ADARD WIEGE			
	DEVELOPMENT ASSESSMENT REPORT		
Application No.	REV/2022/0028		
Address	9 Westbourne Street STANMORE NSW 2048		
Proposal	Section 8.2 review application of refused Determination		
	DA/2022/0034 dated 9 August 2022 for demolition of the existing structures, Torrens title subdivision of the site into 2 lots and		
	construction of a semi-detached dwelling with a garage and studio		
	above at rear to each lot with associated landscaping		
Date of Lodgement	14 October 2022		
Applicant	GAT and Associates Pty Ltd		
Owner	Monument (NSW) Pty Ltd		
	TCEM Investments Pty Ltd		
Number of Submissions	4		
Value of works	\$915,000.00		
Reason for determination at	Review of application determined by the Planning Panel		
Planning Panel	Chronic and the selection of the selection		
Main Issues	Streetscape/local character  Pulls and Ocale		
	Bulk and Scale		
	Overshadowing		
	Visual Privacy		
Recommendation	Approved with Conditions

## 1. Executive Summary

This report is an assessment of the application submitted to Council for a Section 8.2 review application of refused Determination, DA/2022/0034, dated 9 August 2022. The application is for demolition of the existing structures, Torr

Figure 11 Alignment of the proposed rear of the first floor, in line with No. 7 Westbourne Street.

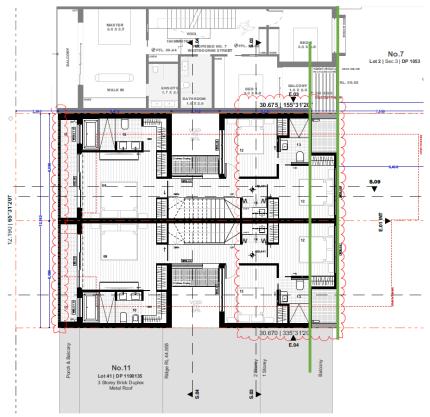
Document Set ID: 36066464 Version: 1, Version Date: 06/10/2022 side walls, and is covered by a roof and has a 1.2m high solid balustrade. The proposed bathroom provides a consistent window sill height and opaque glass louvres which match the appearance of this adjoining balcony. The similar relationship of these elements can be seen in drawing no. DA20 of the architectural plans prepared by Monument Design Partnership + Piensa Architects. Furthermore, on the western elevation, the proposed bathroom adjoins a full width rear balcony to No. 11 Westbourne Street that extends further than the proposed rear setback of the bathroom. Compliance with the adjoining rear building lines, building heights, and setbacks demonstrate that the bathrooms do not result in excessive bulk and scale. Please refer to Figure 11.
